DUKE POWER COMPANY

Re: RII:JPO
50-269, 50-270, 50-287

With regard to IE Bulletin 79-05A which was transmitted by your letter of April 5, 1979, and in reference to my letter of April 10, 1979 on this subject, attached are the responses to Items 7, 8, 10 and 11.

Enclosure 8-1 provides a simplified flow diagram of the Oconee feedwater systems. The valve positions shown reflect the current system status during normal operation.

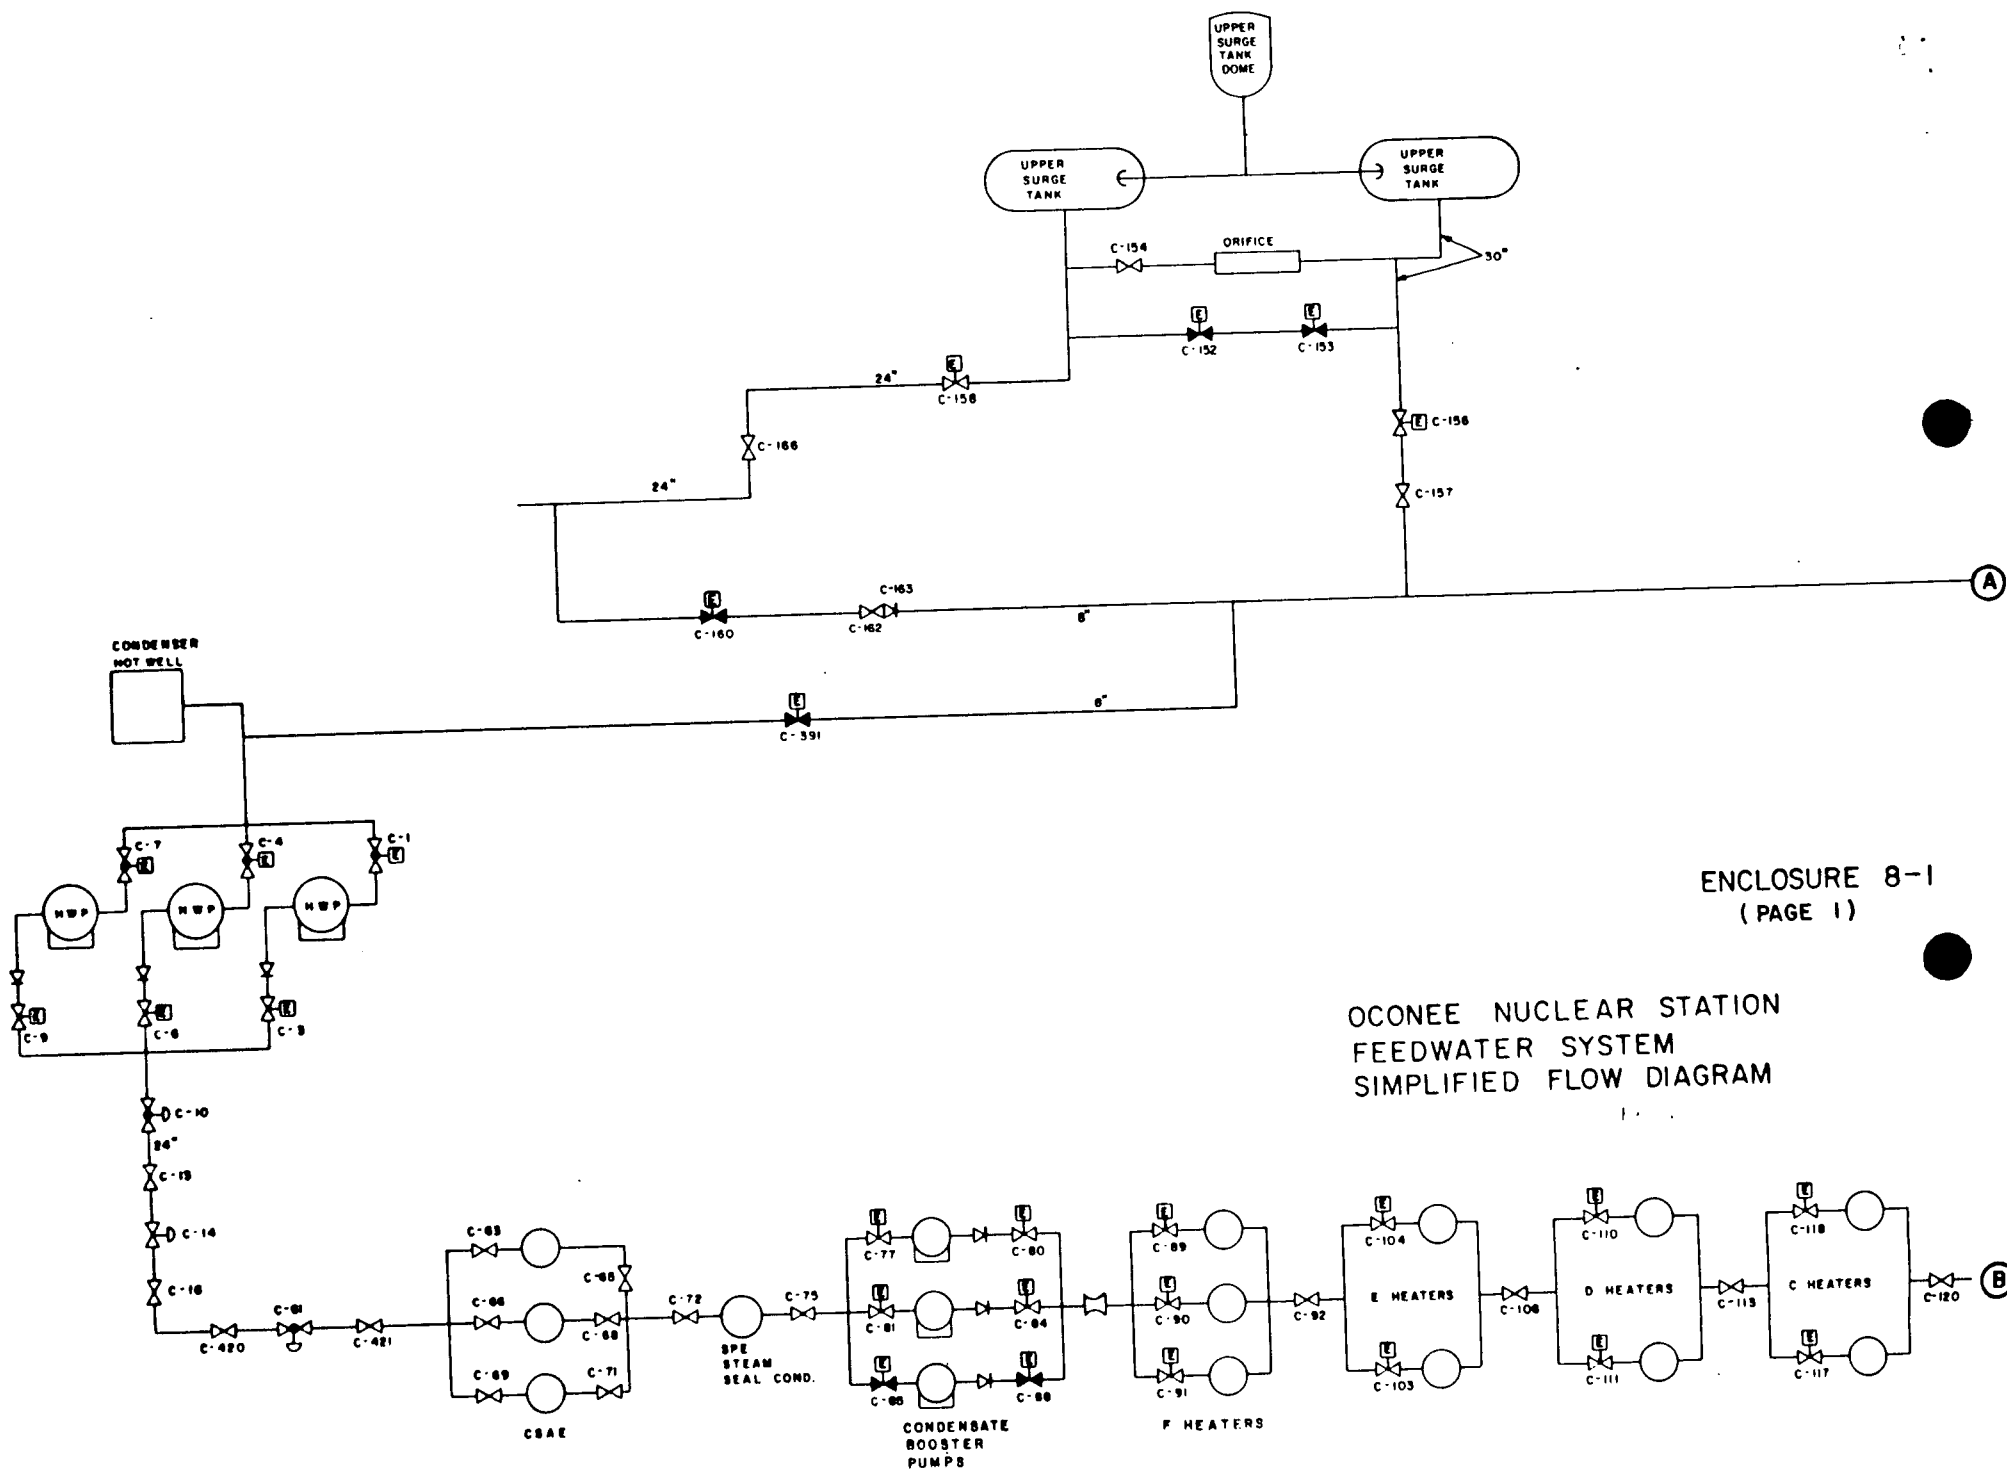
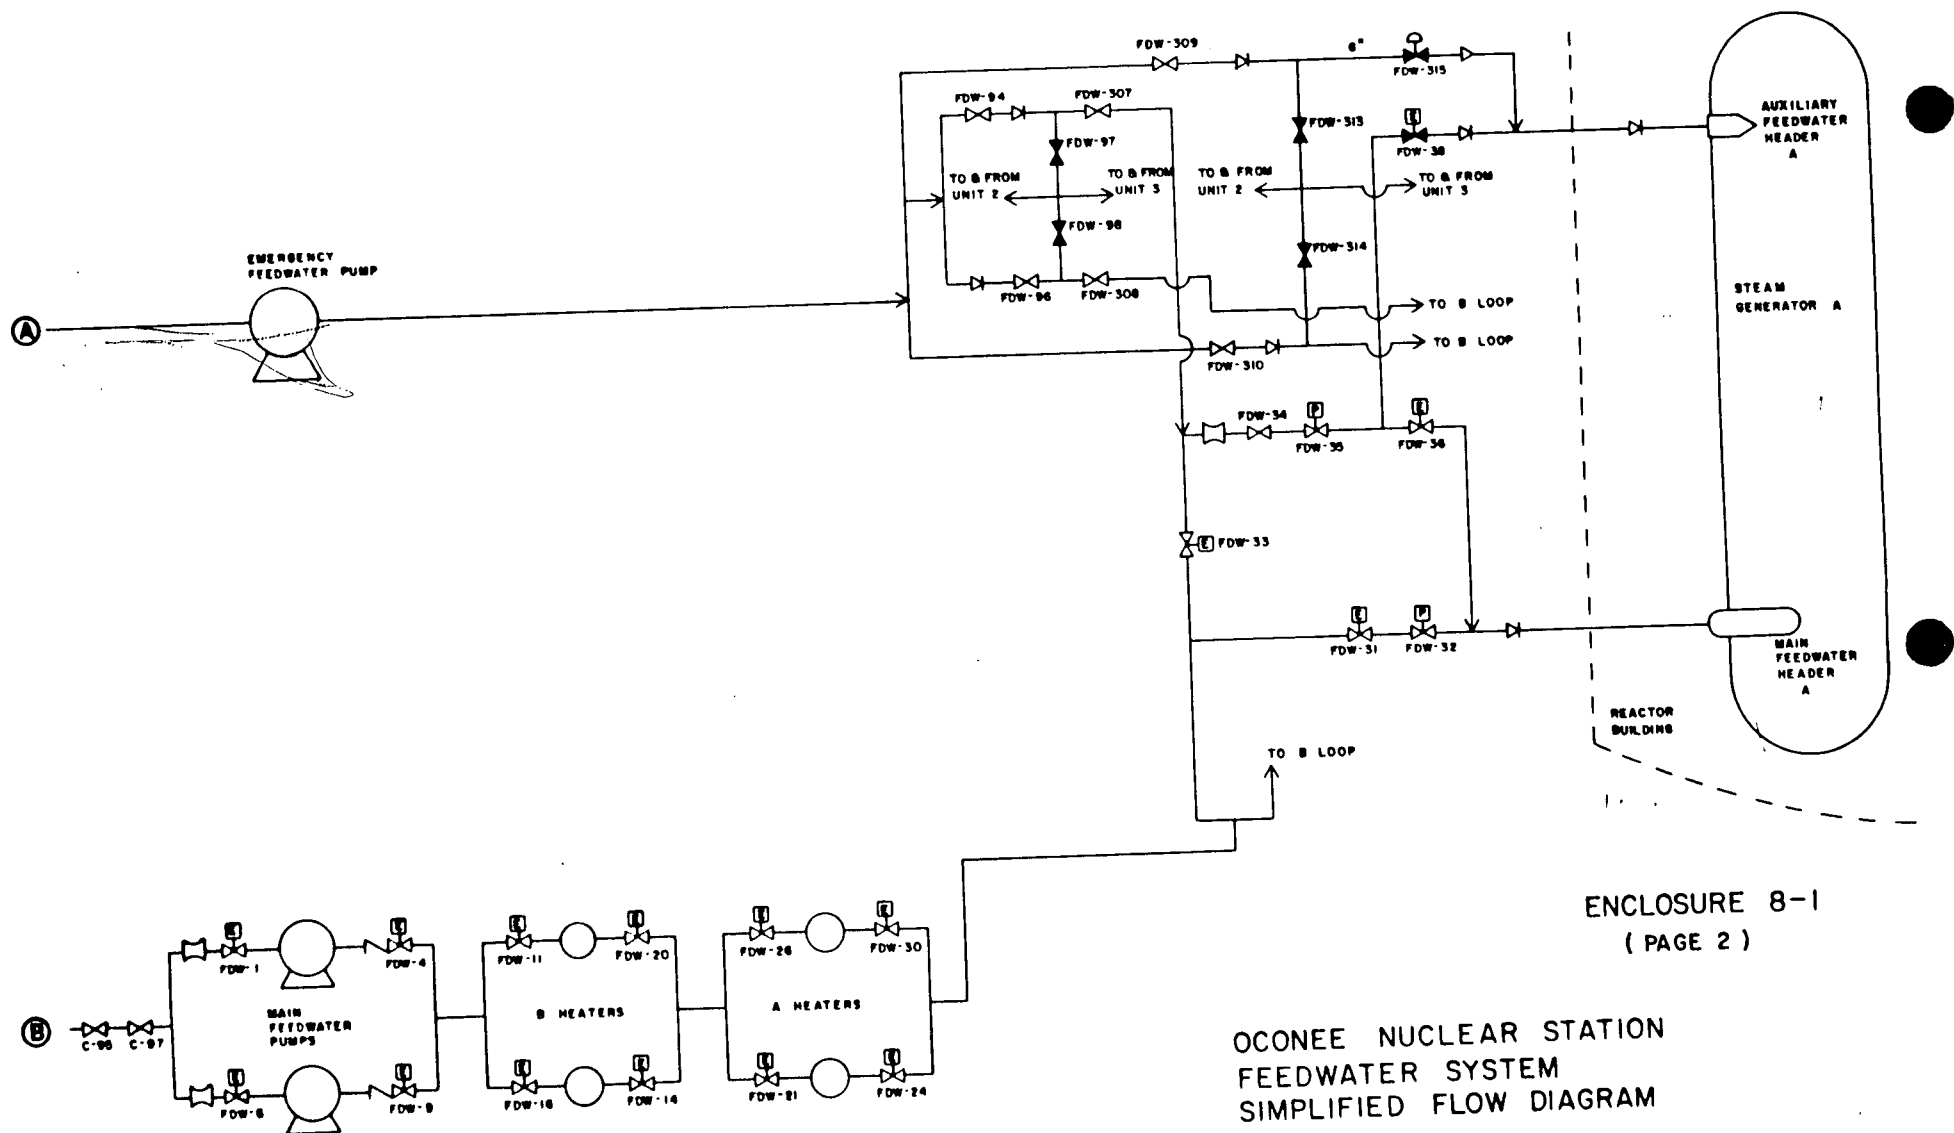
Prepare and implement immediately procedures which assure that two independent steam generator auxiliary feedwater flow paths, each with 100% flow capacity, are operable at any time when heat removal from the primary system is through the steam generators. When two independent 100% capacity flow paths are not available, the capacity shall be restored within 72 hours or the plant shall be placed in a cooling mode which does not rely on steam generators for cooling within the next 12 hours.

When at least one 100% capacity flow path is not available, the reactor shall be made subcritical within one hour and the facility placed in a shutdown cooling mode which does not rely on steam generators for cooling within 12 hours or at the maximum safe shutdown rate.

For the Oconee units during normal operation there exist two independent steam generator feedwater flow paths, each with capacity to remove a decay heat load of 5% FP whenever heat removal from the primary system is through the steam generators—refer to Oconee Nuclear Station Technical Specification 3.4.1. One flow path is the main feedwater and condensate system, which begins at the condenser hotwell and terminates at the steam generator main feedwater header. All the valves in this train are open during normal operation. The feedwater flow through this flow path is supplied by the combination of a hotwell pump (3 motor driven pumps normally available), a condensate booster pump (3 motor driven pumps normally available), and a main feedwater pump (2 turbine driven pumps normally available); or a hotwell pump and condensate booster pump.

The other flow path is the emergency feedwater system, which begins at the emergency feedwater pump suction from the upper surge tanks or, alternatively the condenser hotwells, and terminates at the steam generator auxiliary feedwater header. All the valves in this train are open during normal operation, with the exception of the emergency feedwater header block valve (FDW-38 and -47) to each steam generator and except during periods of testing. The block valves open when the normal feedwater flow is lost, either upon loss of main feedwater pumps or low feedwater pump discharge pressure. The feedwater flow through this flow path is supplied by a turbine driven emergency feedwater pump.

In addition to these two independent flow paths, two alternate flow paths for emergency feedwater can be made available for each unit. These are (1) a redundant emergency feedwater line from the emergency feedwater pump discharge to the steam generator emergency header bypassing the emergency feedwater header block valves and (2) cross connect of the emergency feedwater pump discharge header to both discharge headers of the emergency feedwater pumps of the other two Oconee units, making the emergency feedwater pump of either of the other units available to supply emergency feedwater in the event of a particular emergency feedwater pump becomes inoperable. Operator action is required to place these two alternate flow paths in service.

- (1) Whenever the reactor is critical, if an emergency feedwater header block valve is determined to be inoperable, then within two hours the valve in the redundant emergency feedwater line (FDW-315 or -316) shall be opened and their controls in the Control Room tagged to denote the required position.

- (2) Whenever the reactor is critical, if the emergency feedwater pump is determined to be inoperable, then within two hours an open flow path for emergency feedwater shall be established from the emergency feedwater pump discharge header to another unit which is subcritical to the redundant emergency feedwater header of the affected unit and the controls for the emergency feedwater pump in the Control Room tagged to denote the requirement for start up of the other unit's feedwater pump, when required. If the inoperable emergency feedwater pump is not returned to an operable status within 72 hours, or if an emergency feedwater pump from another unit is not made available within two hours of determination of the inoperable emergency feedwater pump, the affected unit will be shut down at the maximum safe shutdown rate and placed in the decay heat cooling mode. This maximum safe shutdown rate is considered to be approximately two to four hours for the time period "power operation" to subcritical and an additional 24 hours for cool-down to the decay heat cooling mode.

- (3) Whenever the reactor is subcritical, the main feedwater train is inoperable and the emergency feedwater system is being used for cooling the steam generators (e.g., hot shutdown mode), within 72 hours either the main feedwater train shall be returned to operation or the unit will be placed in the decay heat cooling mode.
